7ABC BAYHAM STREET CAMDEN LIFESTYLE

SECTION 73 PROPOSED SCHEME AMENDMENTS
PLANNING APPLICATION
NOVEMBER 2020

This document has been prepared to present the amendments to the consented scheme (Ref: 2018/3647/P) which are predominantly internal and designed to suit the hotel brand.

SECTION A-A

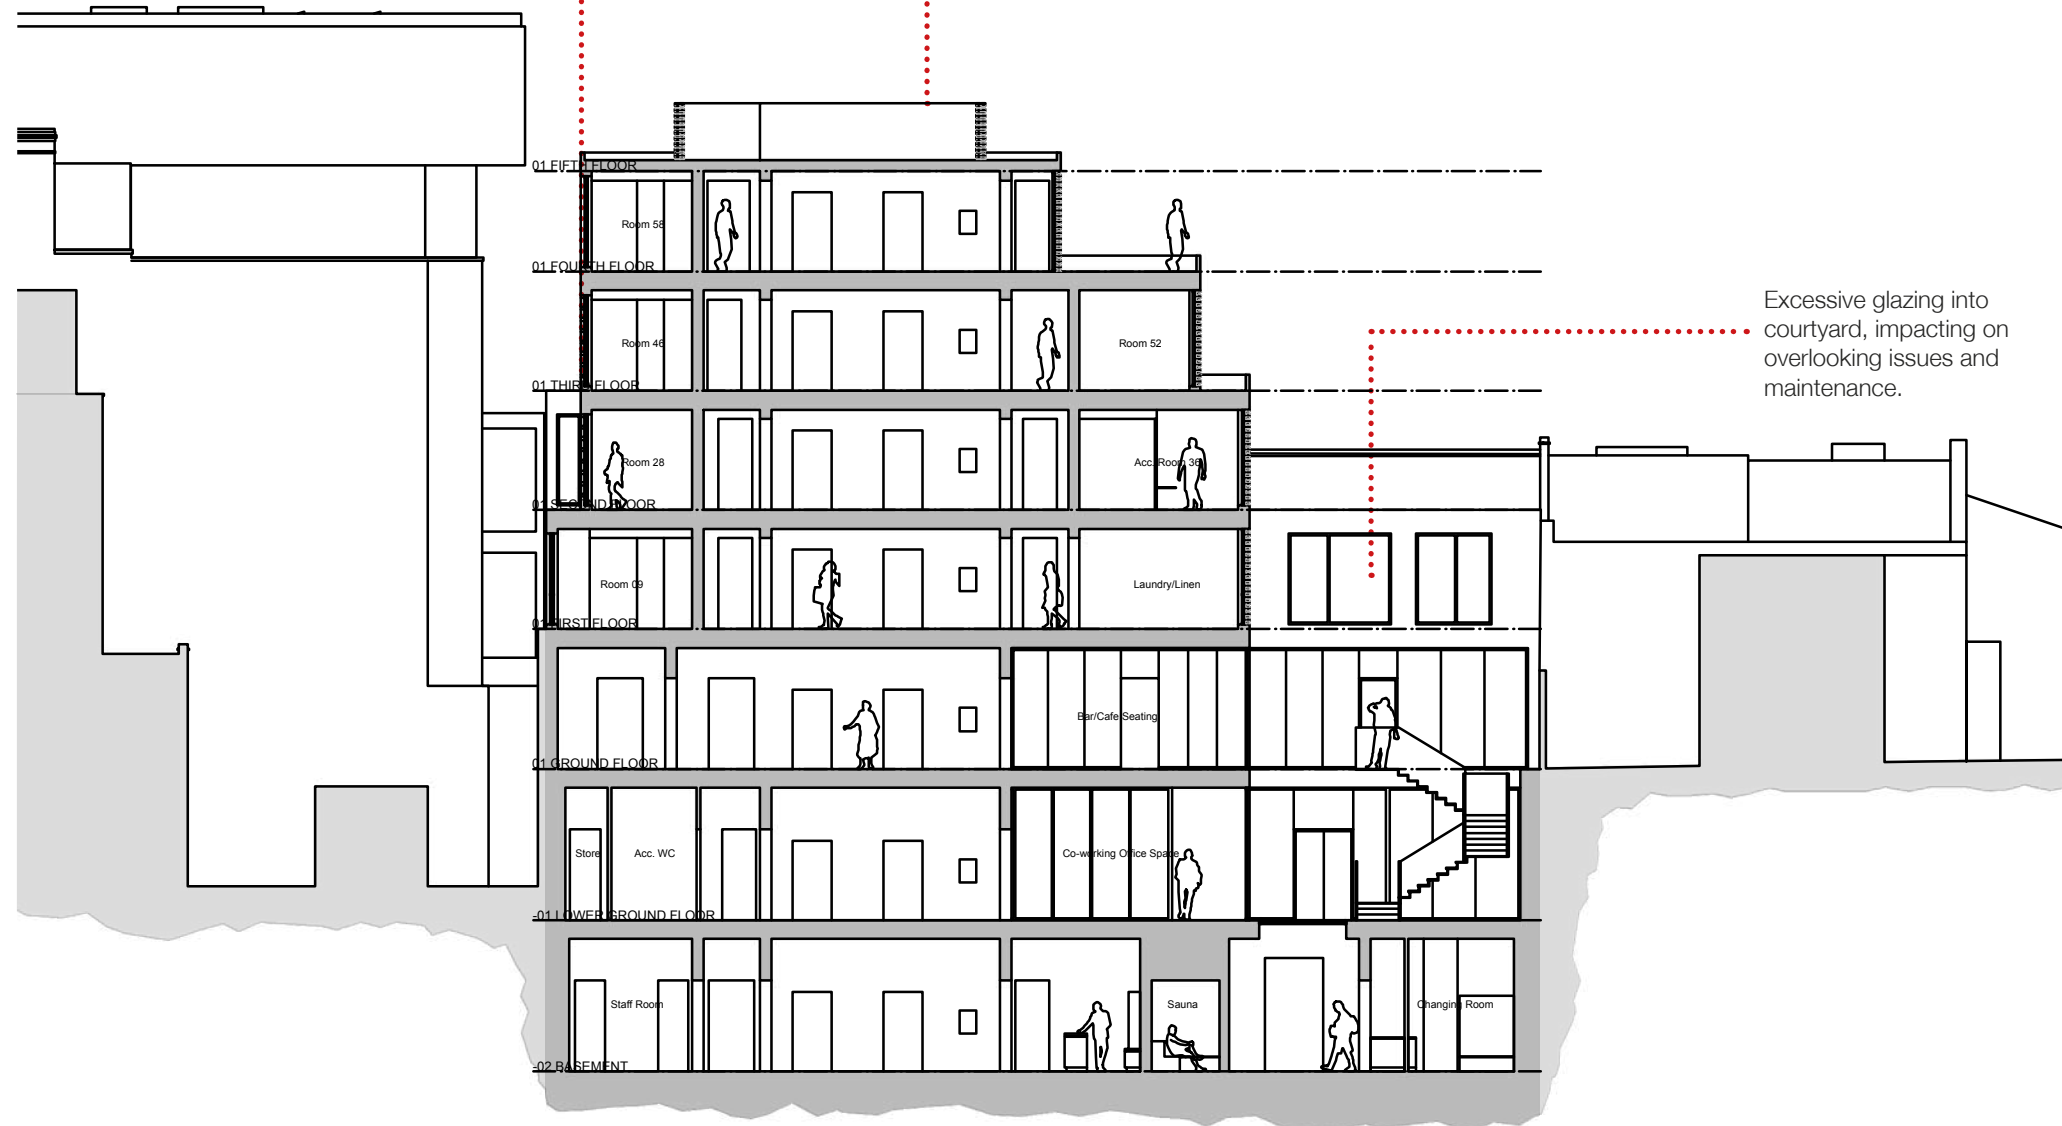
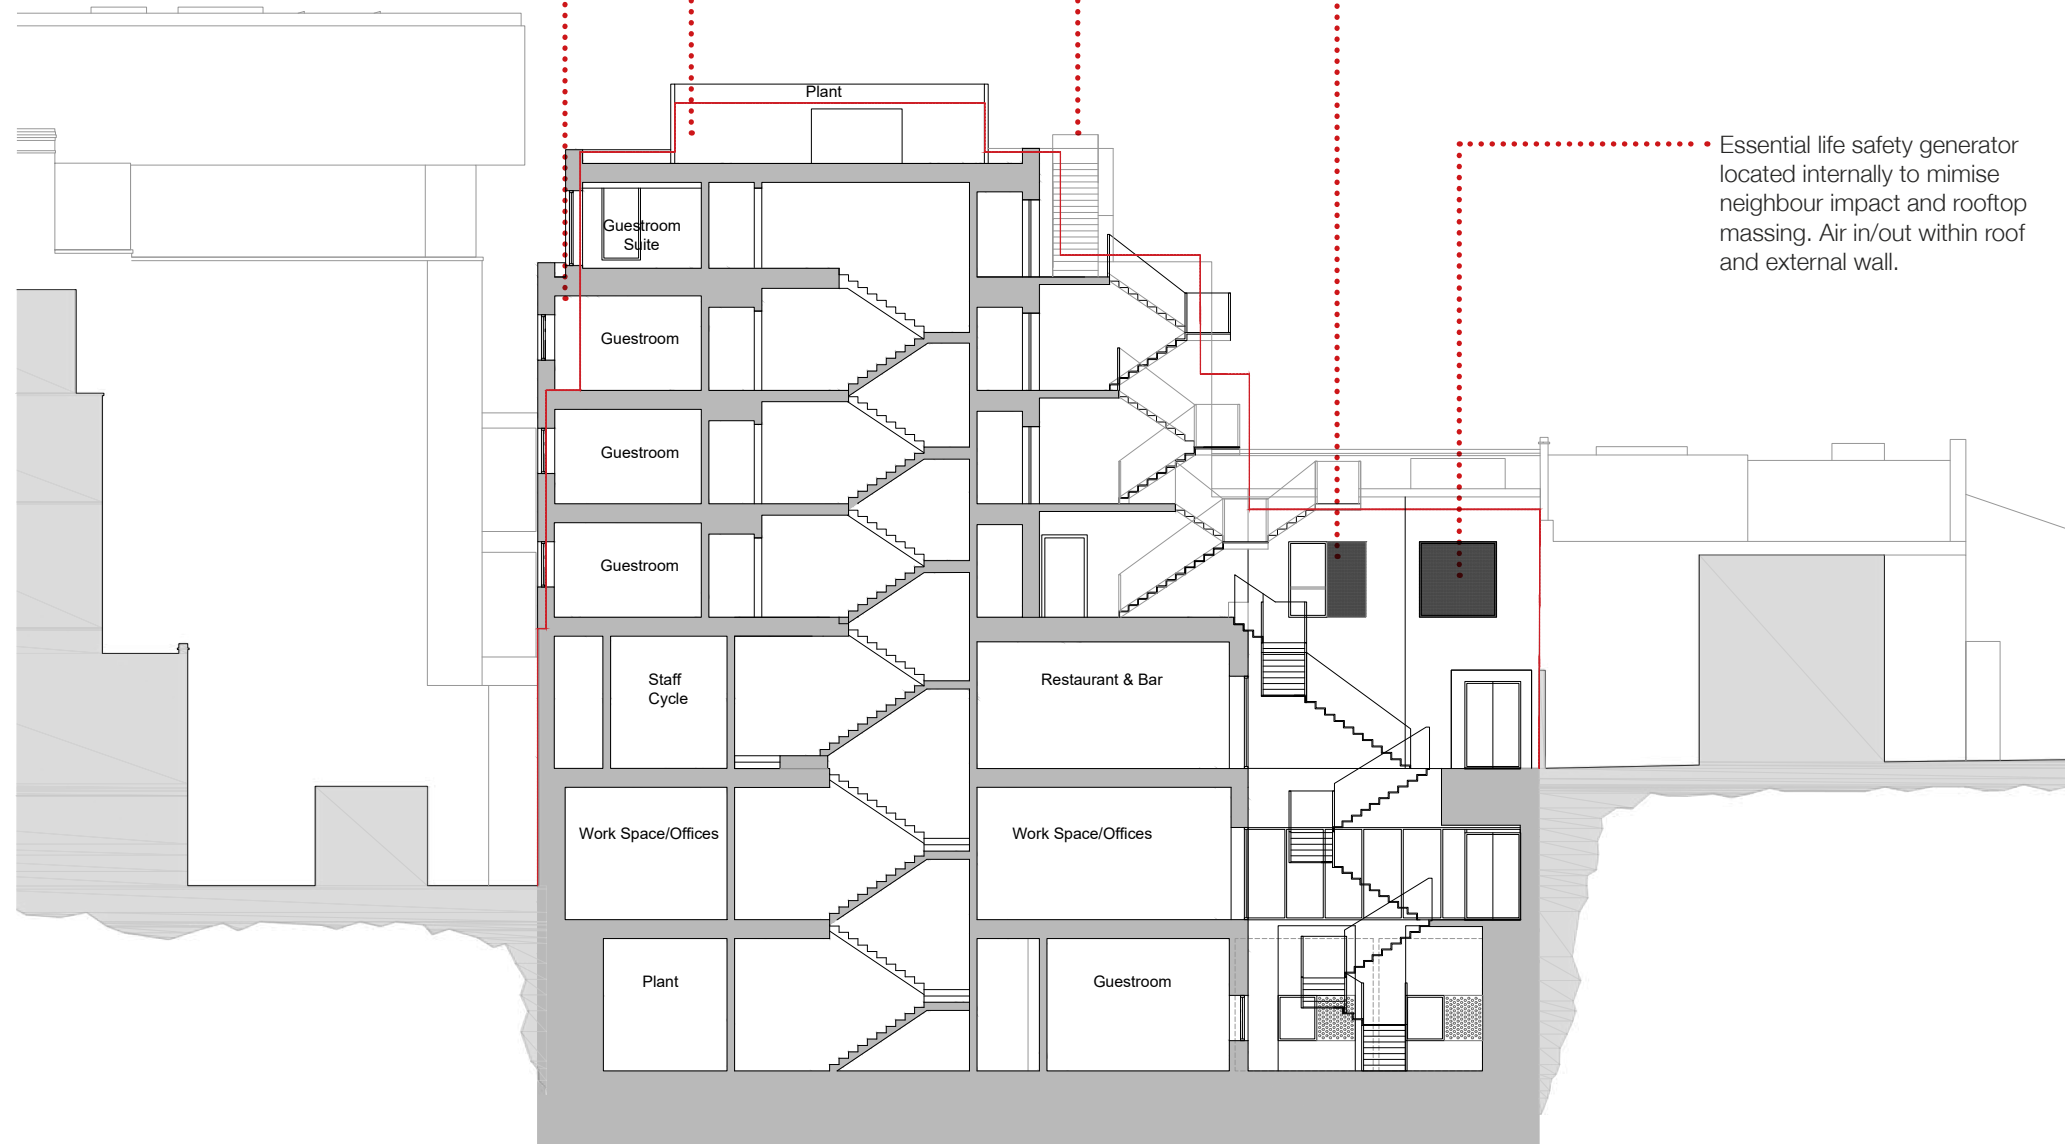
Excessive glazing into courtyard, impacting on overlooking issues and maintenance.

Plant screen height not adequate for servicing of hotel.
No provision for access to plant area.

South facade simplified by reducing glazing extent to minimise overlooking and enhance neighbouring courtyard.

Plant Screen height now taller to sufficiently accommodate for MEP requirements.

External secondary escape stair woven into the building fabric.

Courtyard fenestration reduced to minimise overlooking and fire risk.

Essential life safety generator located internally to minimise neighbour impact and rooftop massing. Air in/out within roof and external wall.

- General massing retained with only slight increase to rooftop plant screen to enable to shielding of required proposed plant.
- Insufficient plant screen height was allowed for within the consented scheme, mechanical plant will be required to serve a scheme of this nature.

1. Supply and extract ventilation is to be provided to the hotel and common areas, this will be via a centralised air handling unit (complete with heat recovery). The AHU is to be located on the roof.
2. High efficiency Variable Refrigerant Volume/Flow (VRV/VRF) equipment will operate as the main communal heating (and cooling) system for the building located on the roof.
3. Planning consent states that the kitchen extract must vent to the roof.

The installation of these systems are required at a height of 2.1m to ensure they are suitably hidden from view.

SECTION B-B
PROPOSED

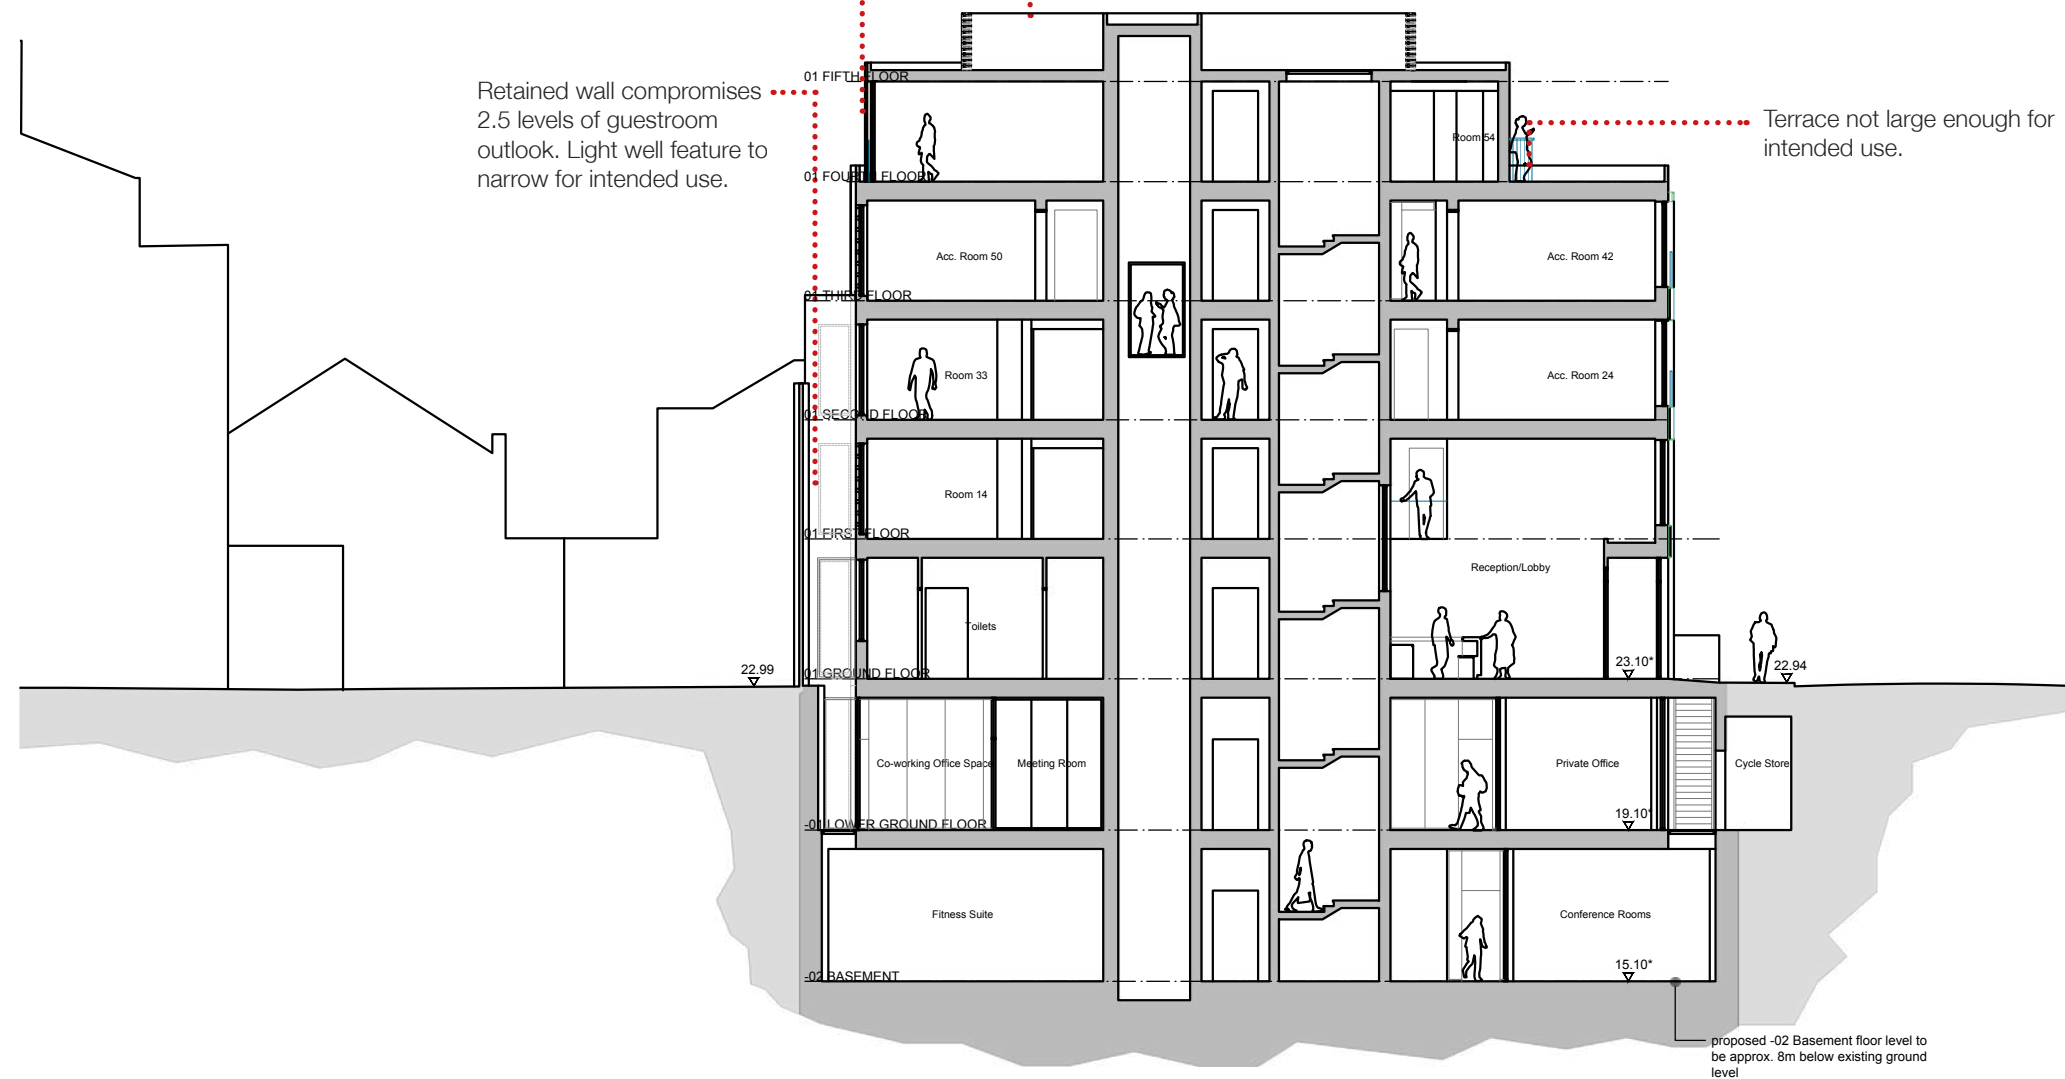
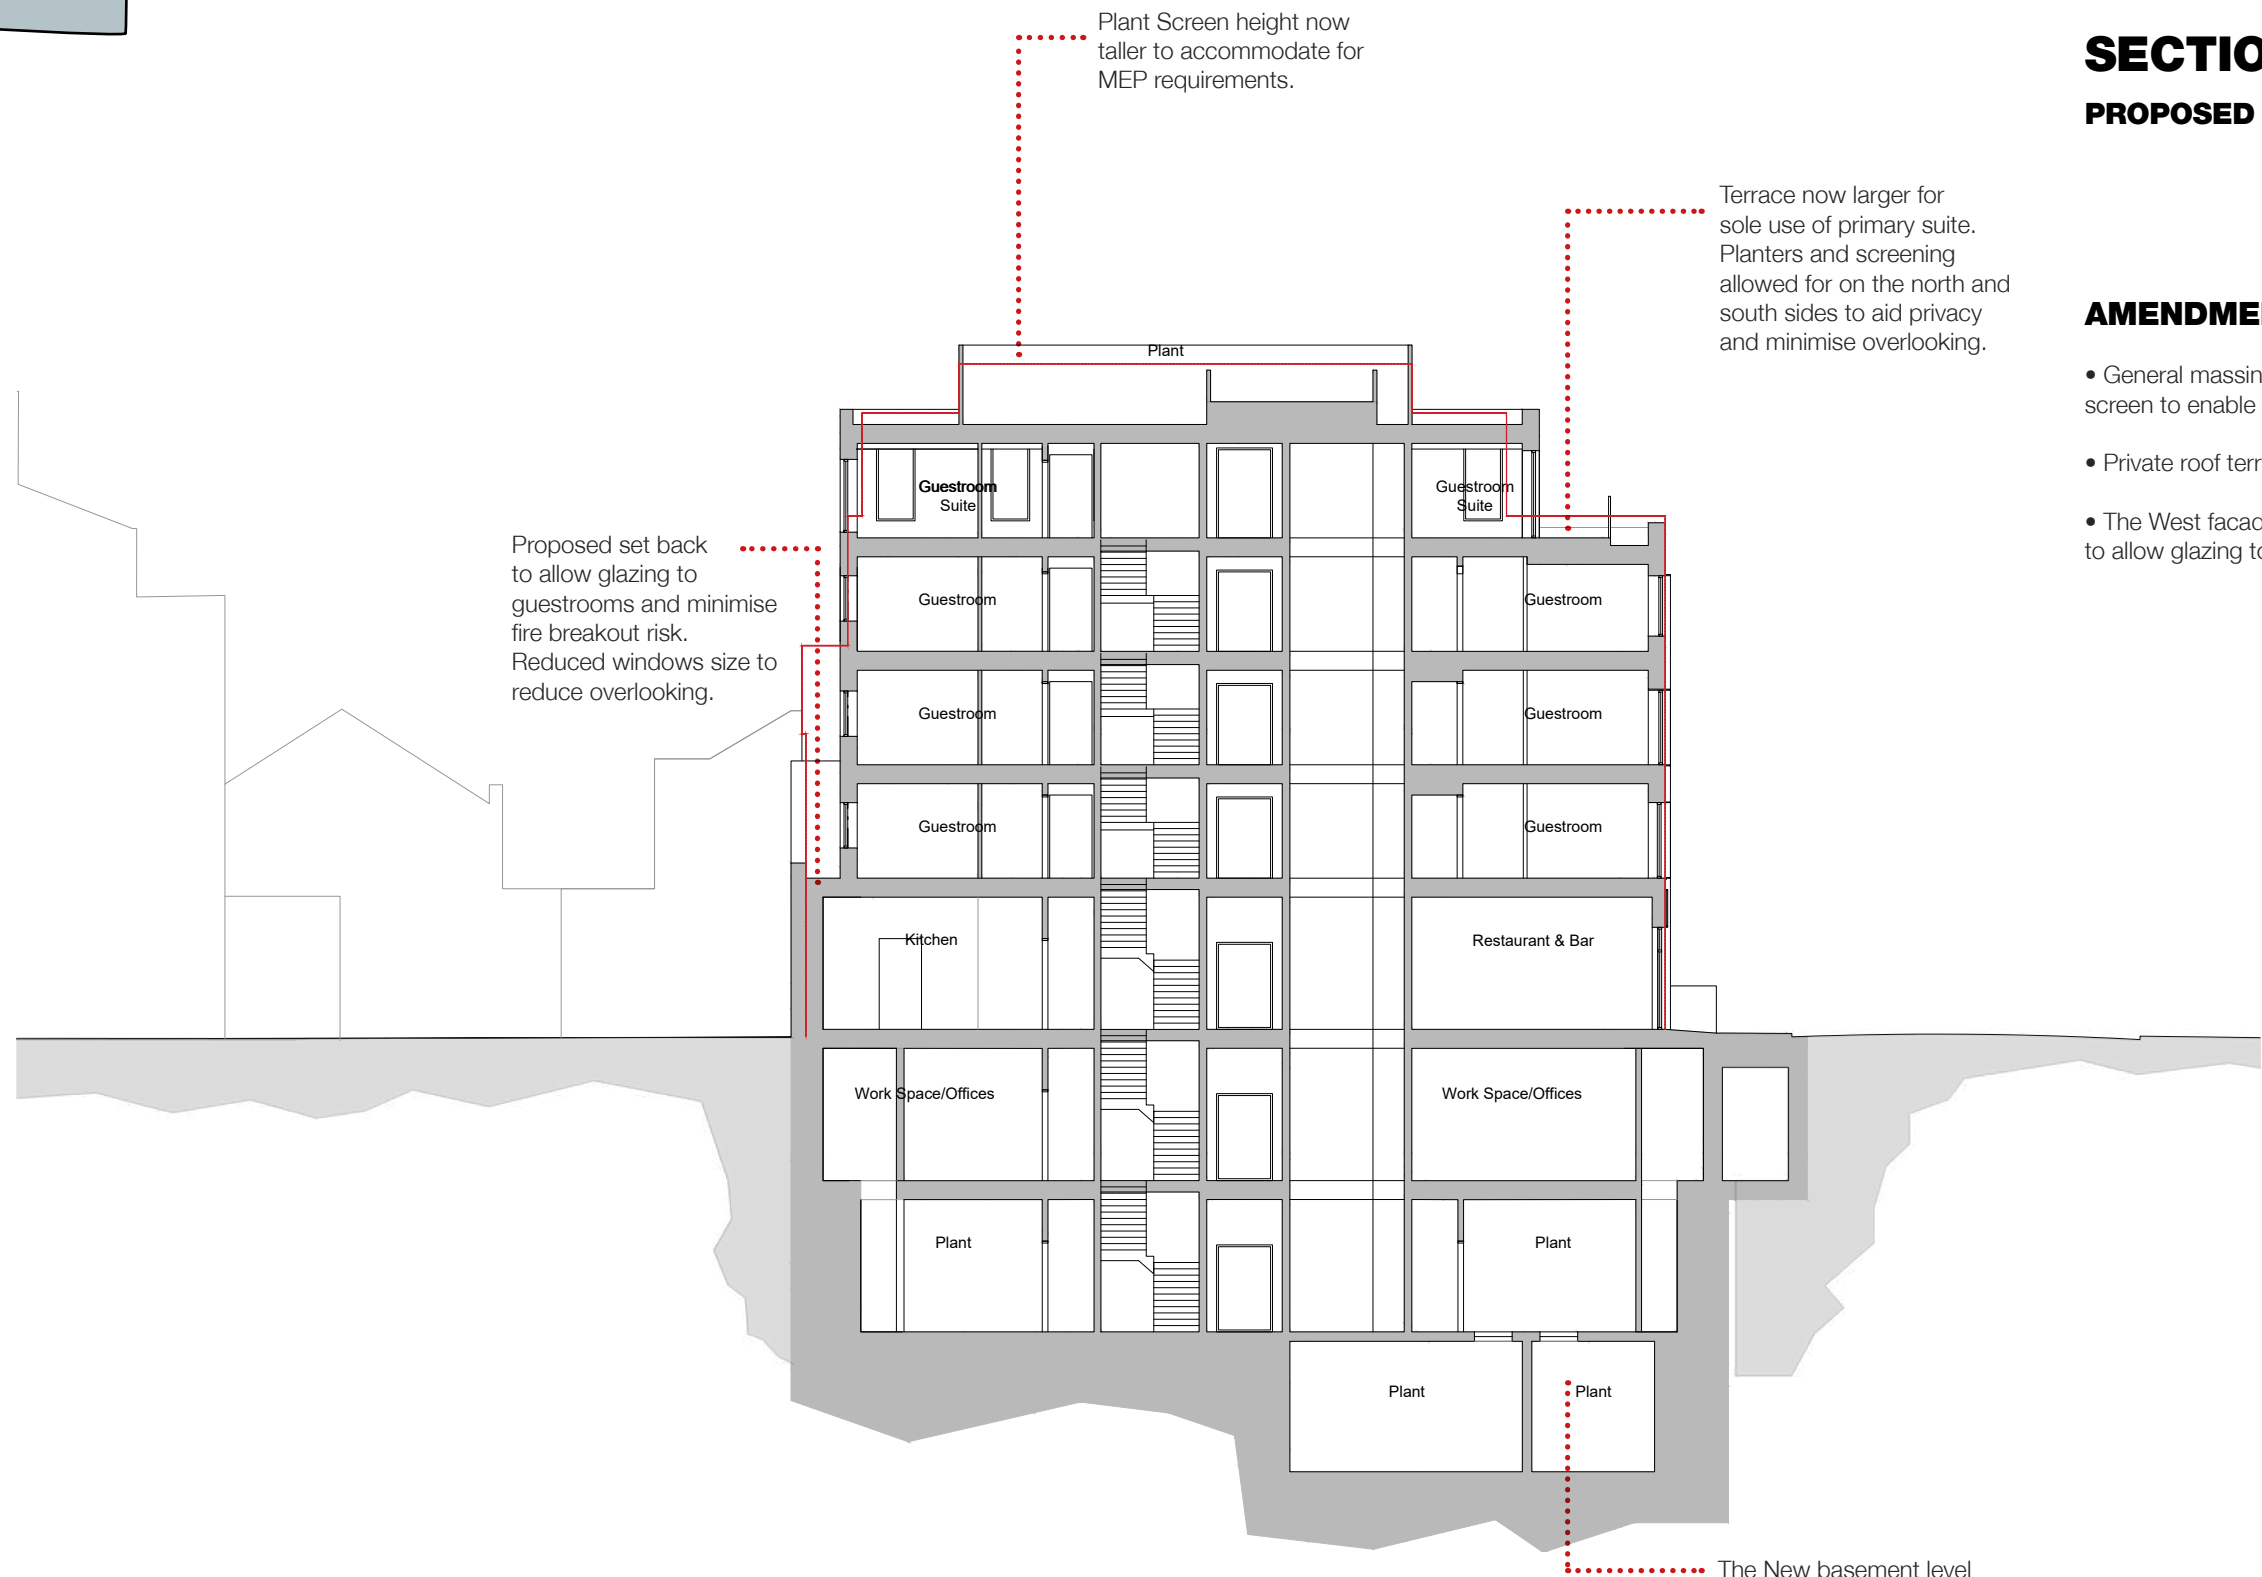
Excessive glazing on west facade impacting on overlooking issues and maintenance.

Plant screen height not adequate for servicing of hotel.
No provision for access to plant area.

Retained wall compromises 2.5 levels of guestroom outlook. Light well feature to narrow for intended use.

Terrace not large enough for intended use.

- General massing retained with only slight increase to rooftop plant screen to enable to sheilding of proposed plant.
- Private roof terrace to primary suite shown.
- The West facade has been revised to step away from the boundary to allow glazing to guestrooms and minimise fire breakout risk.
